Date: December 11, 2018

RE: Response to USEPA Request for Alternate Purging and Sampling Method
for Long-Screen Wells
Army Creek Landfill Superfund Site, New Castle County, Delaware

Revised Table 2 - Monitoring Point Construction and Sampling Method Information
Revised Figure 2 – Proposed Western Lobe Monitoring Well Locations

FIGURE 2	REVIEW	CHECK	DATE	DESIGN	REV. 0	FILE NO.	PROJECT NO.	TITLE	PROJECT	<div></div>
				BAR	SCALE: AS SHOWN	1899295-0001-004	013-6062.007	PROPOSED WESTERN LOBE MONITORING WELL LOCATIONS	Army Creek Landfill Superfund Site New Castle, Delaware	
				AM	12/11/2018

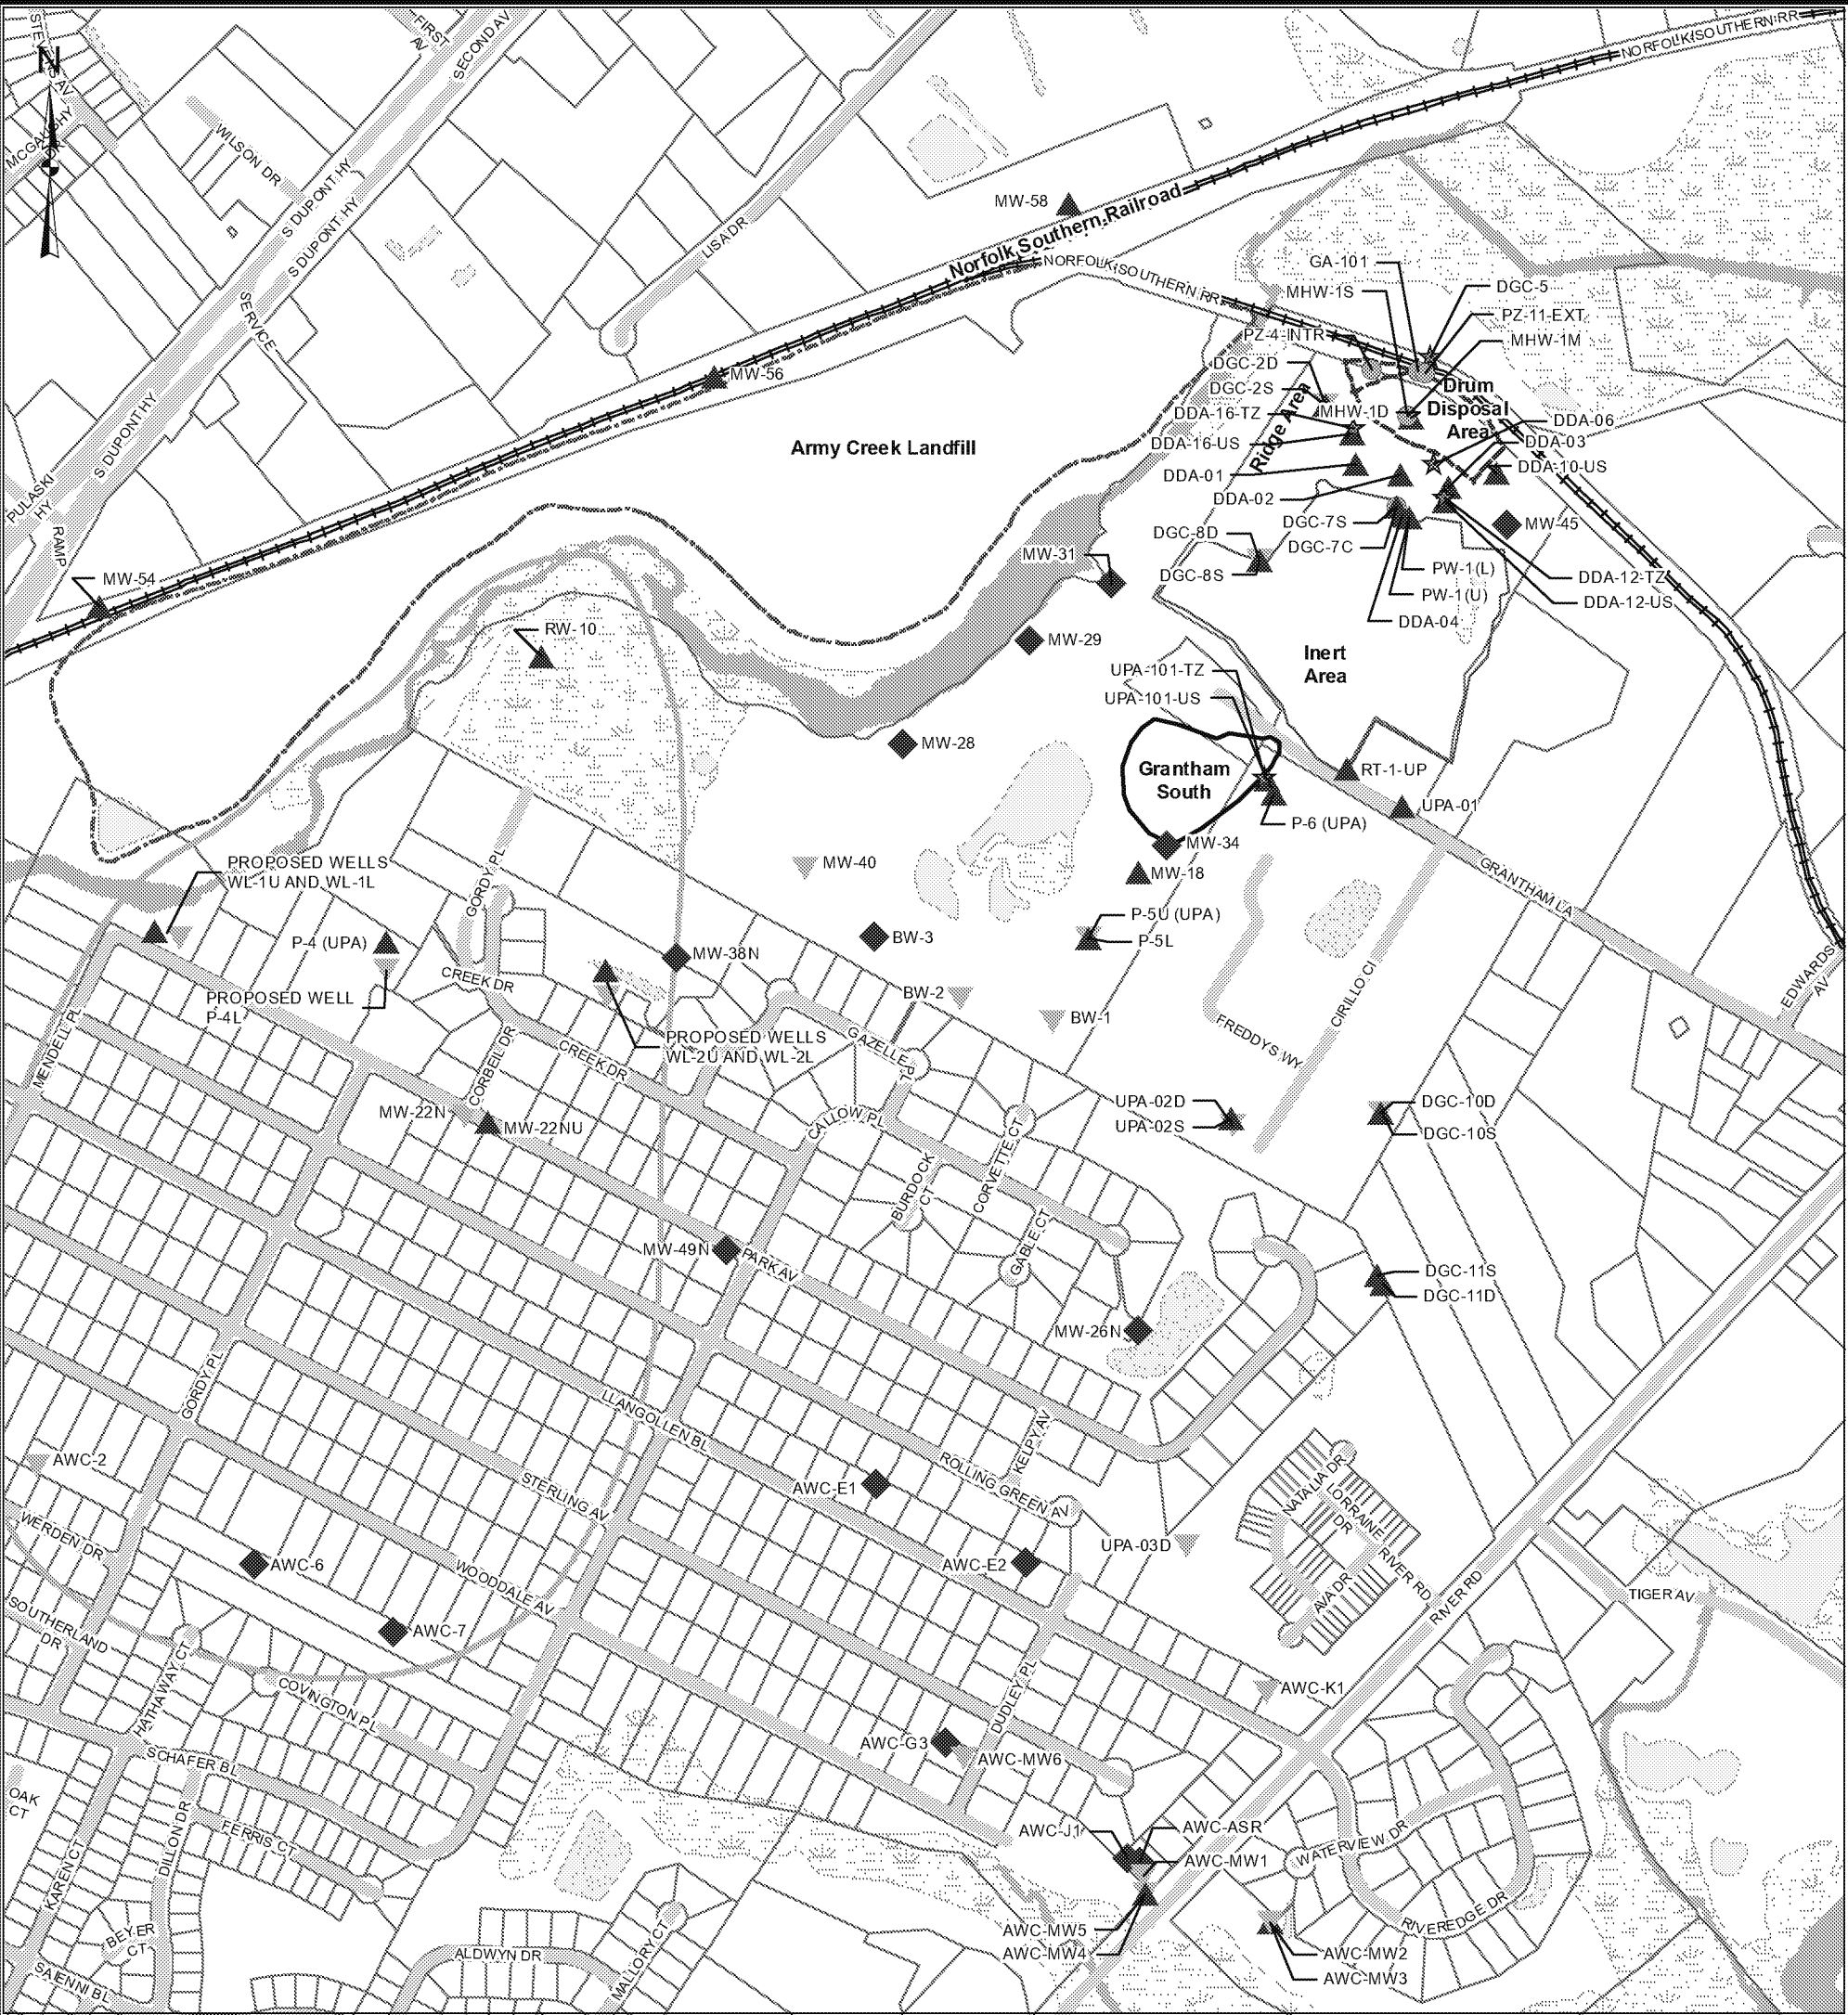
- Wells in key locations for conceptual site model (CSM) development with particularly long screens or potential significant heterogeneity within a long screen were targeted for comparison. These areas and wells include:
 - Western Lobe Study Area: P-4 and MW-22N
 - Screened across both UPA upper and lower sand: BW-3, MW-28, MW-29, and MW-31
 - PFAS Evaluation: MW-28, MW-29, MW-31 and MW-58
- Wells selected by DS&G for a similar volume averaging evaluation were not selected.

In addition, approximately two weeks prior to purging and sampling wells MW-28, MW-29, MW-31, and BW-3 (each of which is screened across both the Upper Potomac Aquifer [UPA] upper and lower sands), an electromagnetic flow-meter will be used to log the vertical flow within the wells and adjustments to proposed low-flow purging and sampling depths will be made, if necessary.

Based on discussions between the USEPA and the Site representatives regarding the appropriate purging and sampling techniques for long-screen wells, the revised Additional Investigation Work Plan and Sampling and Analysis Plan (SAP) will include use of low-flow purging and sampling techniques consistent with historical practices combined with collection of a subset of samples using volumetric averaging (3-well-volume purging followed by sample collection). A table summarizing the construction of the wells in the monitoring program and the sampling methods is attached.
